Project	<b>IEEE 802.16 Broadband Wireless Access Working Group</b> < <a href="http://ieee802.org/16">http://ieee802.org/16</a> >
Title	<b>Clarification of Repetition</b>
Date Submitted	<b>2005-07-20</b>
Source(s)	Jaehye Cho, Seungjoo Maeng, Jaeho Jeon, <a href="mailto:jaehye1.cho@samsung.com">jaehye1.cho@samsung.com</a> Soonyoung Yoon, Jeong-Heon Kim, Jaehyok Lee, Myungkwang Byun, Inseok Hwang, Panyuh Joo, Jiho Jang, Sanghoon Sung, Hoon Huh, janghoon yang, ByoungHa Yi Samsung Electronics Co. Ltd.
Re:	IEEE P802.16-2004/Cor1-D3
Abstract	Clarification of repetition.
Purpose	Adoption of suggested changes into IEEE P802.16-2004/Cor1-D4
Notice	This document has been prepared to assist IEEE 802.16. It is offered as a basis for discussion and is not binding on the contributing individual(s) or organization(s). The material in this document is subject to change in form and content after further study. The contributor(s) reserve(s) the right to add, amend or withdraw material contained herein.

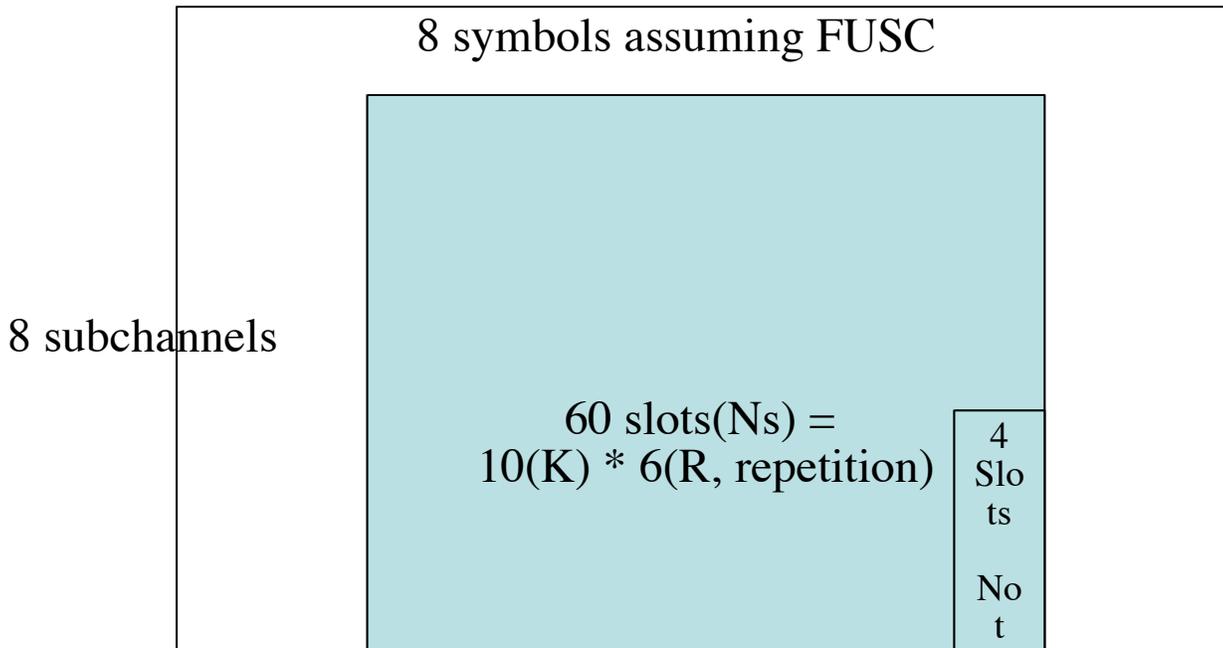
For downlink, it may not be possible to allocate whole multiples of R due to the nature of 2D allocation.

When the number of remaining slots for a DL subframe is not the whole multiples of R(=2,4,6), the slot can't be assigned for a burst that shall use repetition scheme.

It will decrease the scheduling efficiency.

This inefficiency can be avoided by allowing to allocate the slots in the range from the whole multiples of repetition factor R to a whole multiple of the repetition factor R (let's say it K) to K + (R-1) for the downlink.

For example, when the required number of slots before the repetition is 10 and the repetition of R=6 shall be applied for the burst transmission, then the number of the allocated slots (Ns) for the burst can be 60 slots ~ 65 slots. (See the diagram below)

Repetition coding can be used to further increase signal margin over the modulation and FEC mechanisms. In the case of repetition coding,  $R = 2, 4, \text{ or } 6$ , the number of allocated slots ( $N_s$ ) shall be a whole multiple of the repetition factor  $R$  for uplink. For the downlink, the number of the allocated slots ( $N_s$ ) shall be in the range of  $[R * K, R * K + (R - 1)]$ , where  $K$  is the number of the required slots before applying the repetition scheme. For example, when the required number of slots before the repetition is  $10 (= K)$  and the repetition of  $R = 6$  shall be applied for the burst transmission, then the number of the allocated slots ( $N_s$ ) for the burst can be from 60 slots to 65 slots.
